Rezoning Application: RZ-PD 25-0269

**Hillsborough
County Florida**

Development Services Department

1.0 APPLICATION SUMMARY

2.4 Proposed Site Plan (partial provided below for size and orientation purposes. See Section 8.0 for full site plan)

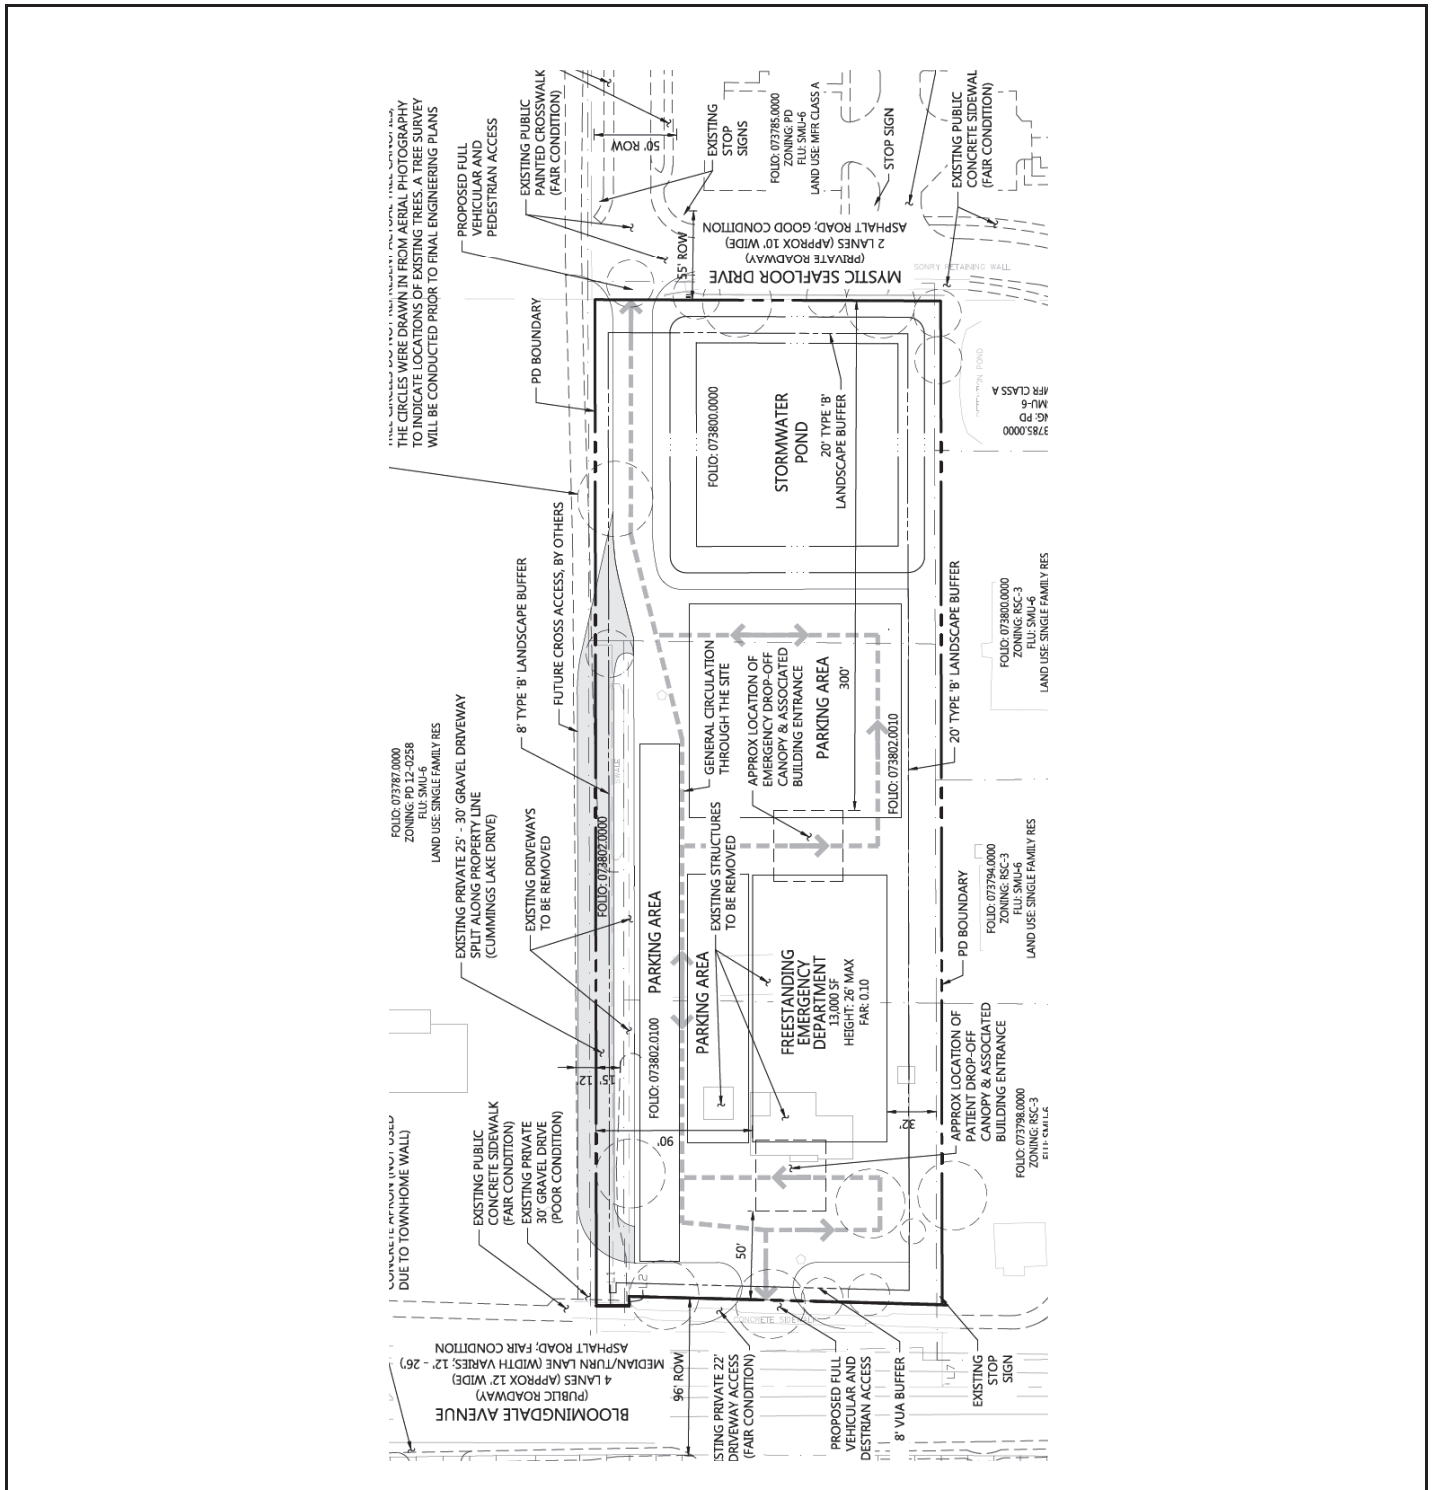
1. Please revise the site plan to show the proposed 10' buffer with Type B screening along the western property line.

Access Spacing Plan
Proposed FSED
10416 Bloomingdale Avenue, Riverview
Source: VHB
Prepared for: Permitting
Date: January 2025

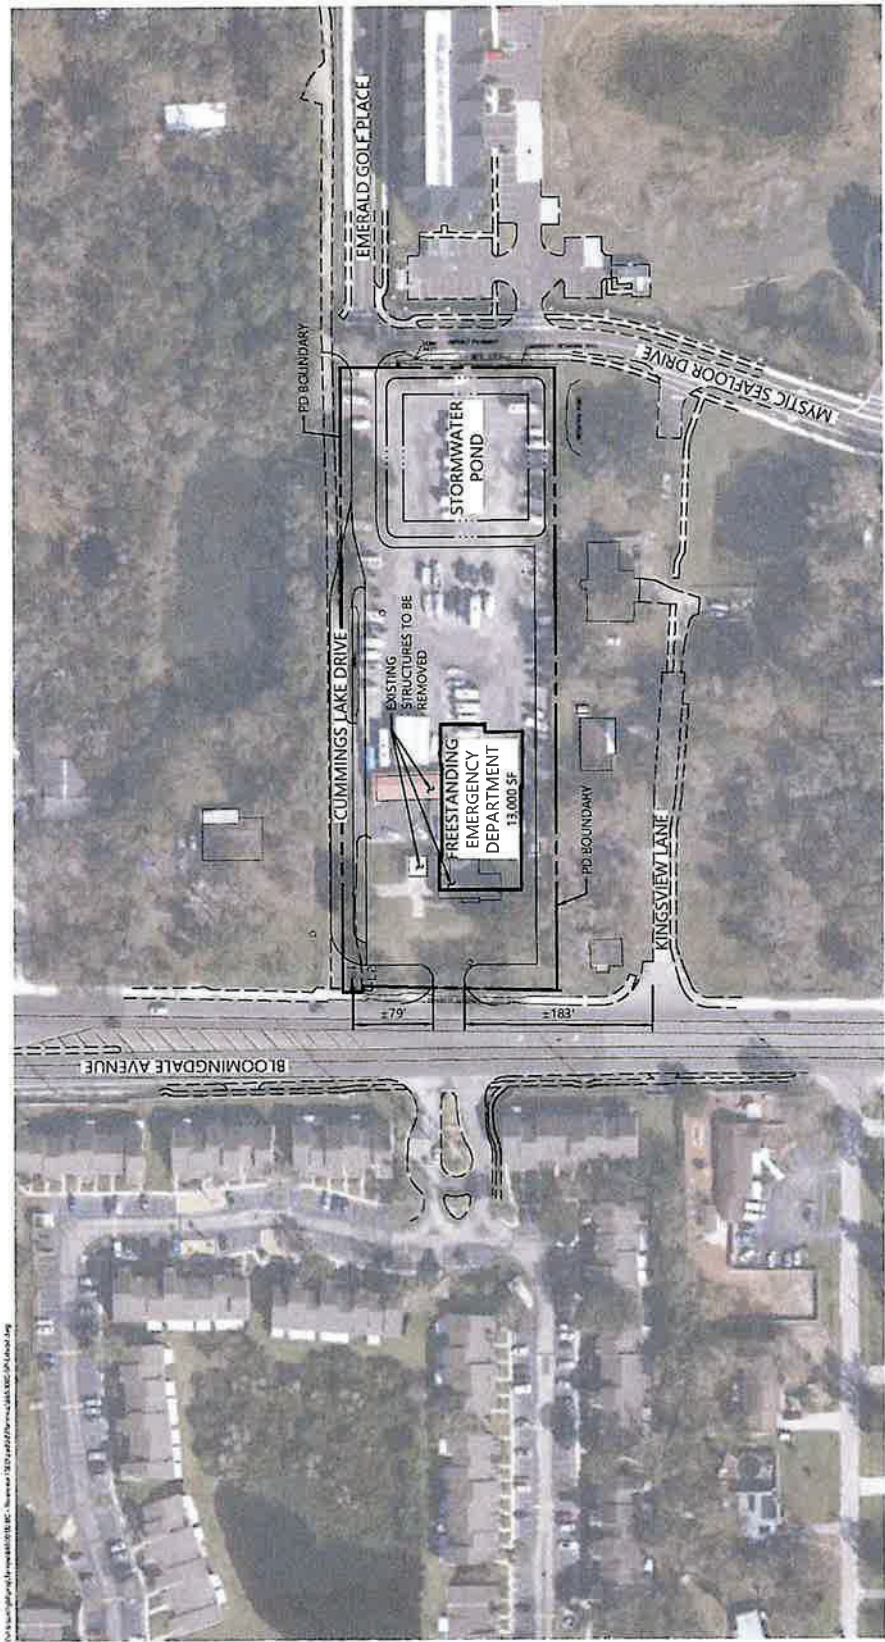
The request is for an Administrative Variance to Section 6.04.07 of the Hillsborough County LDC for the access spacing on Bloomingdale Avenue. Based on Section 6.04.07, the access spacing Bloomingdale Avenue is 245 feet and the distance from the proposed driveway to Cummings Lake Drive to the west is 79 feet and 183 feet to Kingsview Lane as shown on the Access Spacing Plan. In conjunction with the development of the project, the developer proposed to extend a portion of Emerald Golf Place from the current terminus to Bloomingdale Avenue. This is graphically shown in Figure 1. The existing Cummings Lake Drive currently serves the subject property and the property to the west. At the time of development of the property to the west, the remainder of Emerald Golf Place is to be constructed and Cummings Lake Drive will be eliminated. Therefore, the spacing variance request is temporary until such time as the west property is developed.

The applicant's Engineer of Record (EOR) submitted a Section 6.04.02.B. Administrative Variance Request (dated March 4, 2025) from the Section 6.04.07. LDC requirement, governing spacing for the proposed Bloomingdale Ave. access. Per the LDC, Bloomingdale Ave. is a Class 5 roadway, which requires minimum connection spacing of 245 feet. The applicant is proposing the driveway in a location which is +/- 79 feet from Cummings Dr to the west and +/- 183 feet from Kingsview Ln. Based on factors presented in the Administrative Variance Request, the County Engineer found the request approvable on March 14, 2025. If this rezoning is approved, the County Engineer will approve the above referenced Administrative Variance Request.
